December 13, 2012

**RE: Safety-Kleen Systems, Inc. Medley; FLD 984 171 694, Operating Permit No. 56019-
HO-007, Miami-Dade County
First Notice of Deficiencies Dated November 14, 2012**

Safety-Kleen (SK) has prepared this letter in response to the above referenced letter from the Department dated November 14, 2012. We have identified each of the Departments comments in bold, followed by our response. Revised pages of the application are enclosed with this submittal.

Project SK - Medley W.O. No. 13112.21 Sheet 2 of 2
Subject Available Storage Capacity By DS Date 7-16-92
TANK FARM Chkd by VH Date 7/16/92

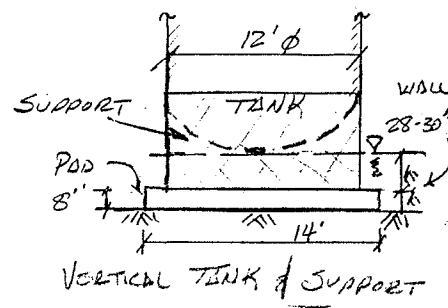
FDEP Comments #34: Page 21 of the Preparedness, Prevention, Contingency Plan, and Emergency Procedures for Daily Business Operations section; The text mentions that the tank area has more than 20,000 gallons of secondary containment but there are no calculations to support this claim. In Appendix C, the engineering calculations (from 1992) are not provided for the secondary containment for the tank farm. Where are the calculations (certified by a PE) related to the volume of containment for the tank farm?

SK Response: The calculations for the secondary containment of the tank farm were mistakenly missing from the original permit application submission. The calculations are included within this submittal.
